Series
38999SIZE 8 SOCKET QUADRAX CONTACT
CRIMP TYPE FOR MIL-DTL-38999 SERIE III
Tensolite NF 24 Q 100 cableIssue:
June 14, 2018Page
1/1

670075011EN

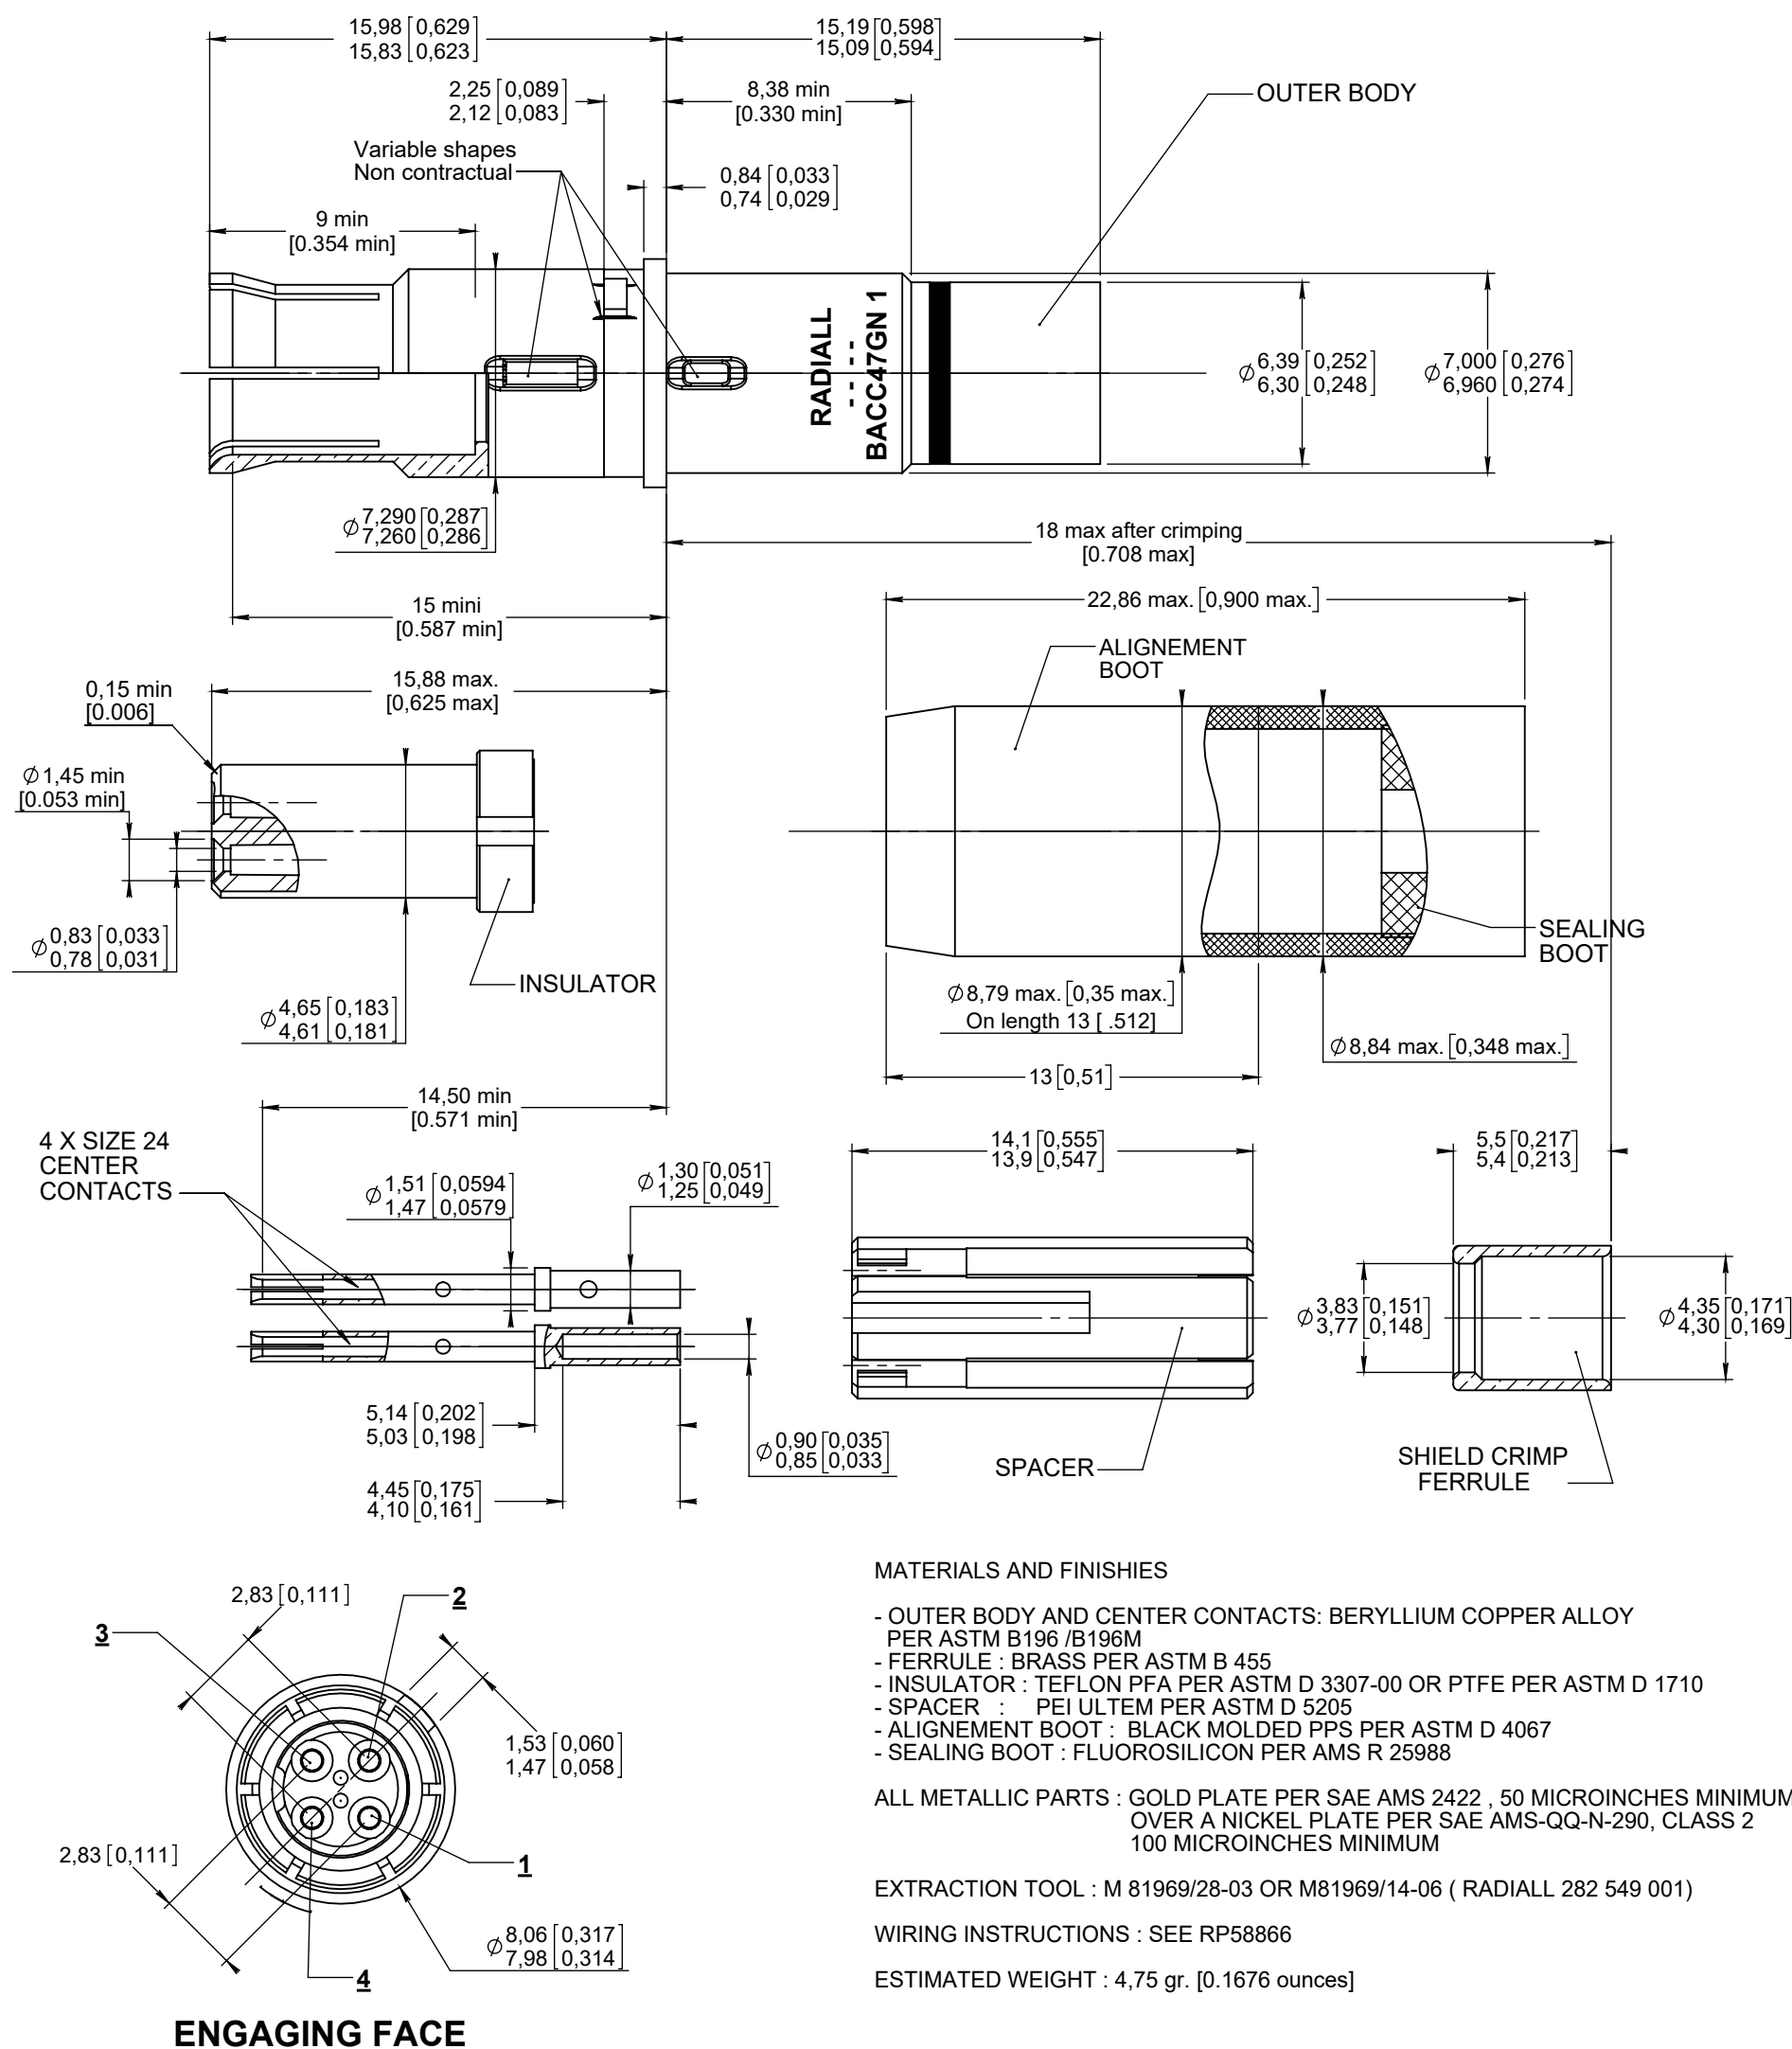
June 14, 2018	Modification of inner contacts cross section	Branjonneau V.	Perrin H.
Aug. 29, 2016	Comment "Variable shapes non contractual" added. Alignment boot: Dim. 13 and Ø 8,84 max. added. Inner contacts: Lenth 4,10/4,45 was 3,59/3,95	Perrin H.	Legendre T.
Feb. 26, 2015	FEP13-17 From date code 15-10, material of alignment sleeve begin black molded PPS (was blue machined PPS) Estimated weight added.	Perrin H.	Le Gloahec Y.
Oct. 14, 2011	Signal contact cavities identif. per BACC47GN added	Perrin H.	Garcia L.
April 5, 2011	Note "qualification in progress" cancelled. TR2008380324 Rear lenght 8.38 min was 8.70	Perrin H.	
12/12/2006	PTFE per ASTM D 1710 was ASTM D 1710	B VAN DER	
Issue	Revisions	Name	Approved
